Access Compliance Report

Public Rights-of-Way

Intersection ID: 31894	Main Street: GREEN_MOUNTAIN_RD	Cross Street: MOUNTAIN_SPRINGS_DR	Location: SW
ADA ID: 89A02BB60952	Ramp Type: PerpDiag	Initial Pass/Fail: Fail	Overall Compliance: No
Severity Score: 22.5			
Codes/Mitigation Info/Possible Solution		Field Measurements/Component Compliance

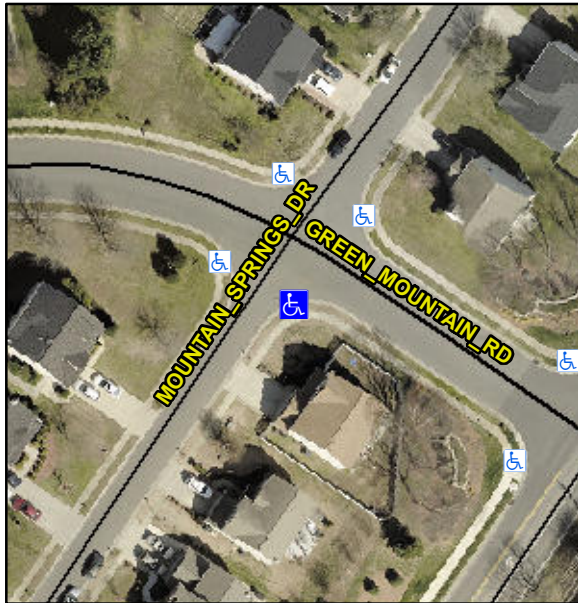
R304.5.1, R304.2.2, R304.5.3

Compliance	Description	Data	Compliance	Description	Data
N/A	Ramp Length (in)	46.0	No	Ramp Slope (%)	10.0
No	Ramp Width (in)	39.0	No	Ramp XSlope (%)	3.0
N/A	Flare Type LT	N/A	N/A	Flare Type RT	N/A
N/A	Flare Slope LT (%)	N/A	N/A	Flare Slope RT (%)	N/A
N/A	Flare Traversable LT?	N/A	N/A	Flare Traversable RT?	N/A
N/A	Landing Length (in)	N/A	N/A	DWS Provided?	N/A
N/A	Landing Width (in)	N/A	N/A	DWS Contrast?	N/A
N/A	Landing Slope (%)	N/A	N/A	DWS Length (in)	N/A
N/A	Landing X Slope (%)	N/A	N/A	DWS Full Width?	N/A
N/A	Landing Curb? (Y/N)	N/A	N/A	DWS Offset (in)	N/A
N/A	Shared Landing?	N/A			
N/A	Gutter Ponding?	N/A	N/A	Gutter Slope (%)	N/A
N/A	Gutter Lip Ht (in)	N/A	N/A	Gutter X Slope (%)	N/A
N/A	Painted X Walk1?	No	N/A	Painted X Walk2?	No
	X Walk 1 Direction	To NE		X Walk 2 Direction	To NW
N/A	X Walk 1 Width (in)	N/A	N/A	X Walk 2 Width (in)	N/A
	X Walk 1 Slope (%)	0.4		X Walk 2 Slope (%)	4.1
	X Walk 1 X Slope (%)	4.6		X Walk 2 X Slope (%)	0.6

Remove & Replace Curb Ramp With Two New Directional Ramps or Equivalent.
